MEMO

To: Julian Clark, Project Engineer From: Garret S. Wyckoff, Planner

Subject: Staff Review Memo of Proposed Site Plan – 6247 Lamphear Road

TOTAL PROVIDED PARKING SPACES

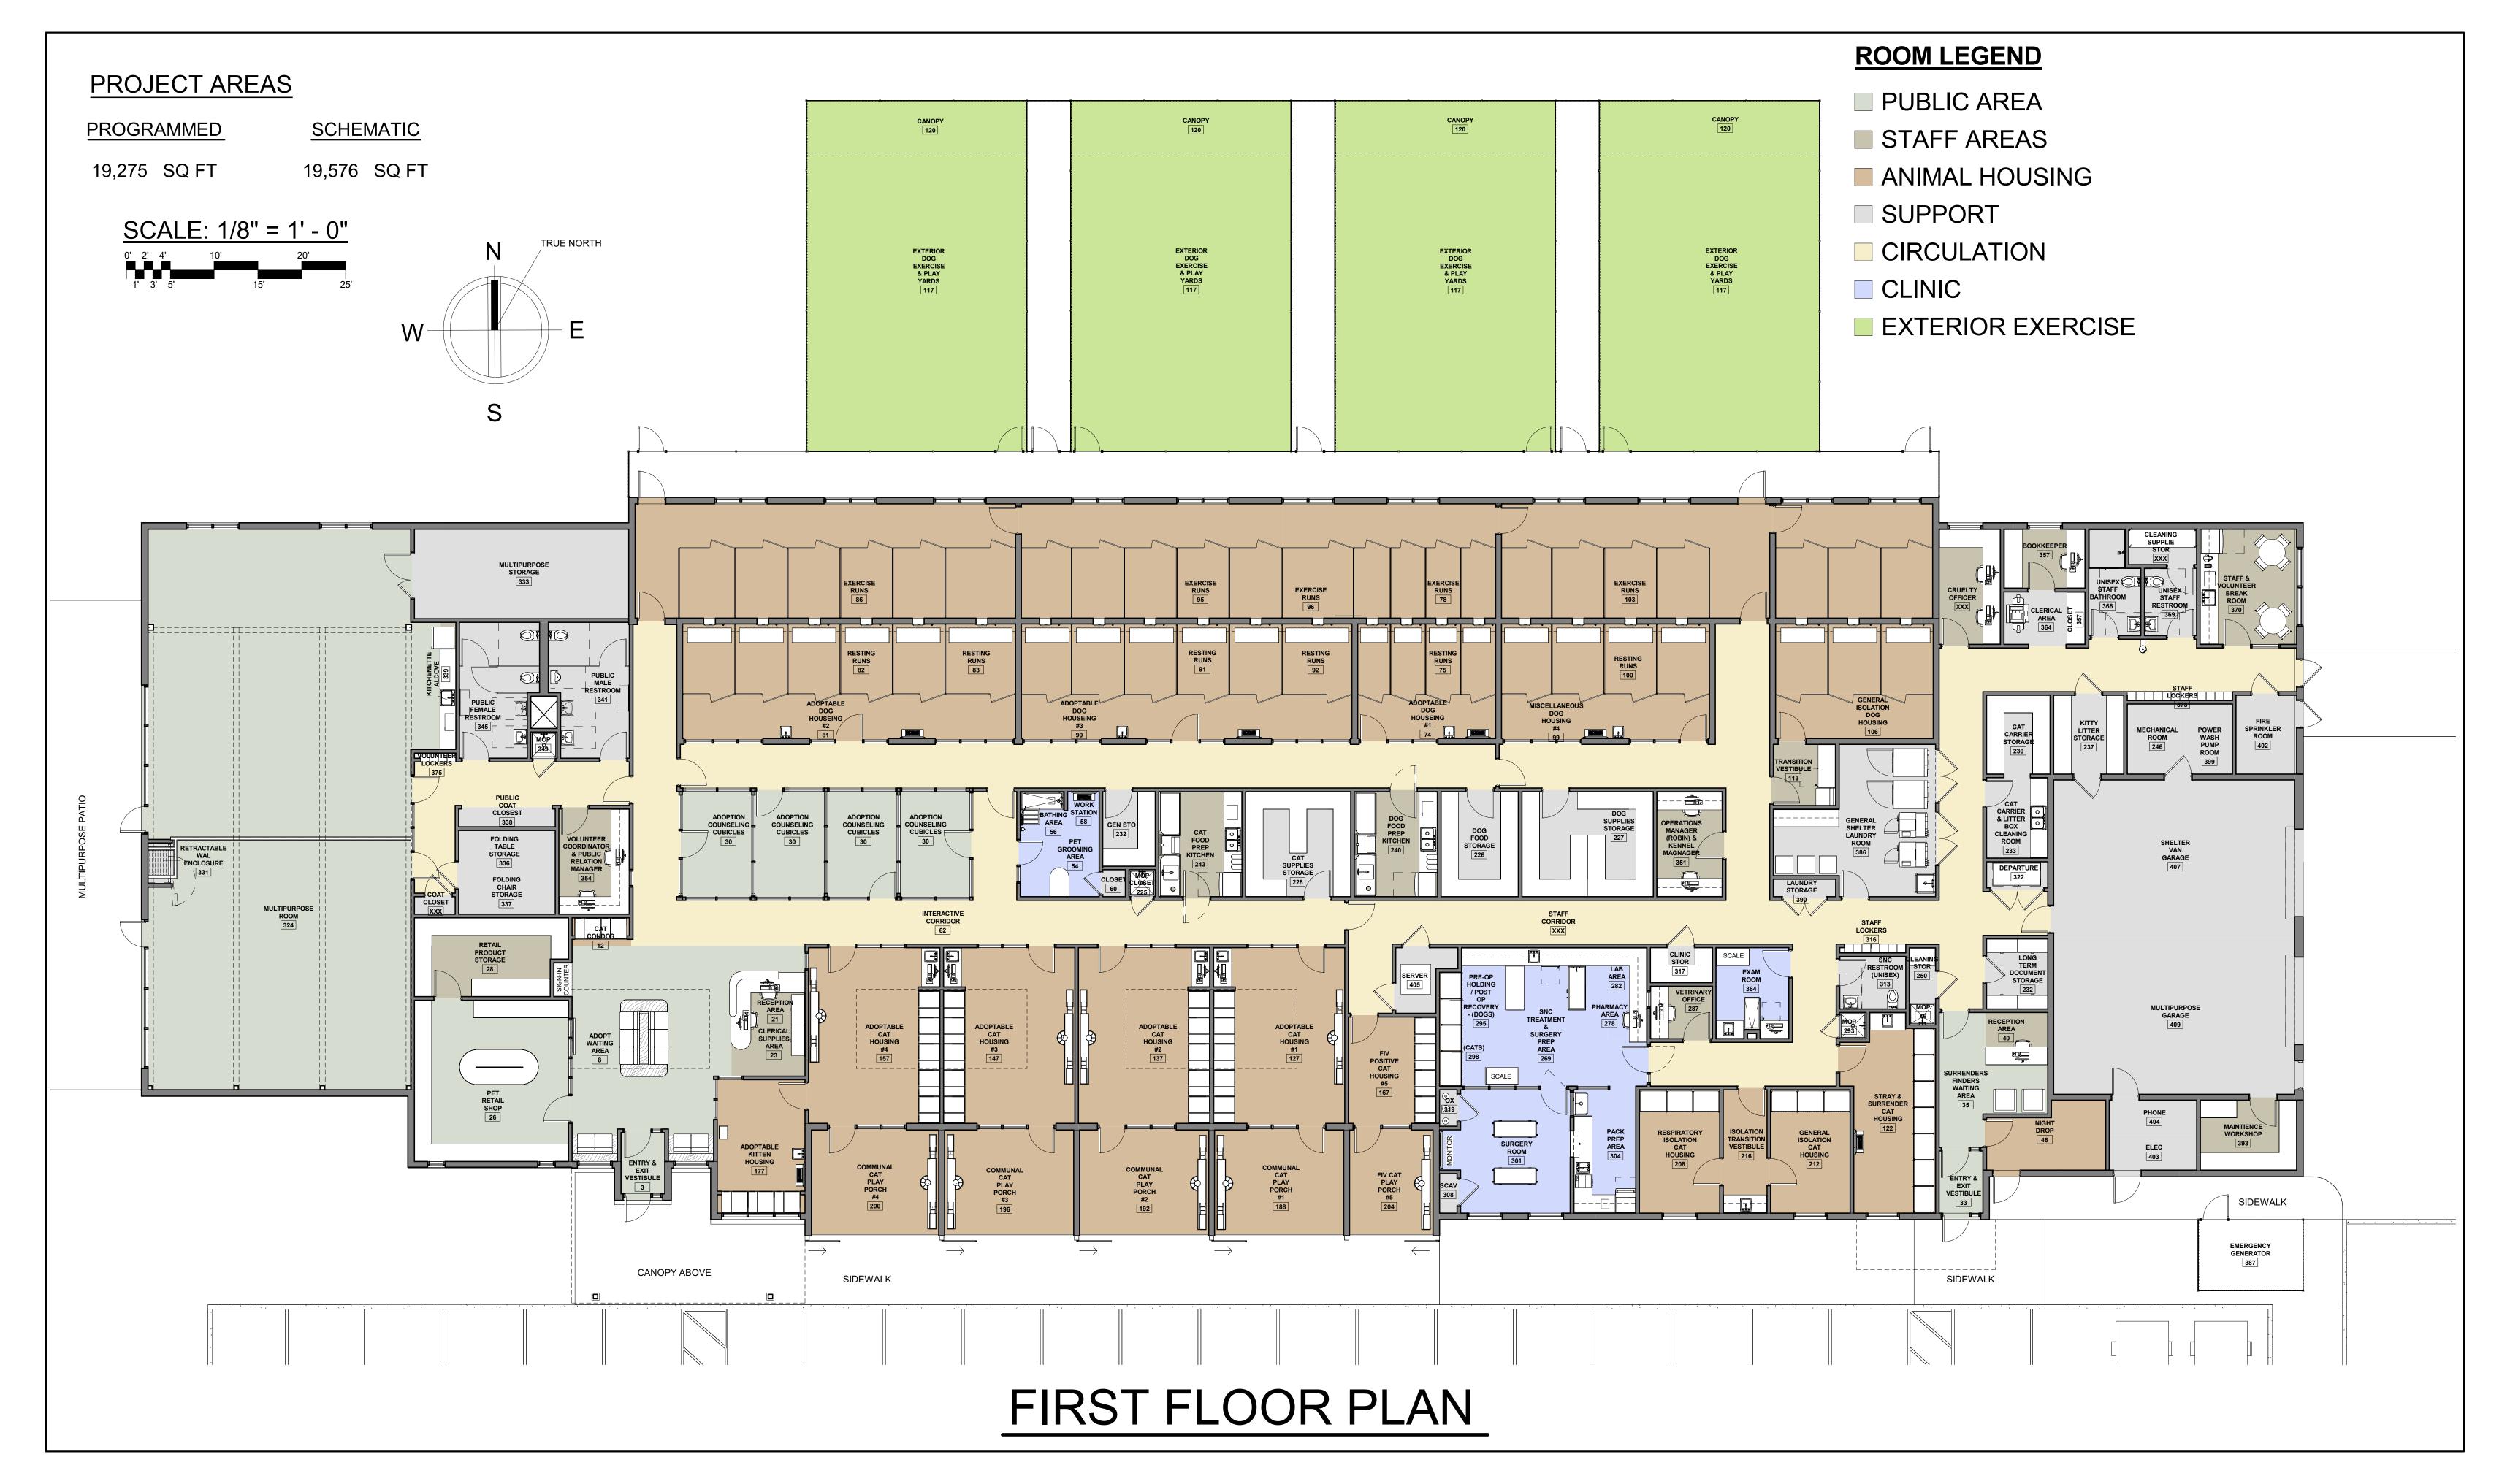
6. Per Table 80-14-1, animal shelters most provide 1 bicycle parking space per 2,500 square feet of gross floor area. Rounded down, this yields a requirement of 7 bicycle parking spaces for a

19,817 square foot facility. Please include the required bicycle parking in the next revision of the proposed site plan package. Design requirements for bicycle parking spaces are located in Section 80-14.8 of the Zoning Code.

7. Per Section 80-15.7(b), All parking lots of 20 or more spaces must provide at least one parking lot island per 10 vehicle parking spaces, and at least one shade tree must be provided for each parking lot island. Please include the required parking lot landscape islands in the next revision of the proposed site plan package. If the strict application of this requirement is infeasible for the project site, an alternative landscape plan can be proposed to the Planning Board.
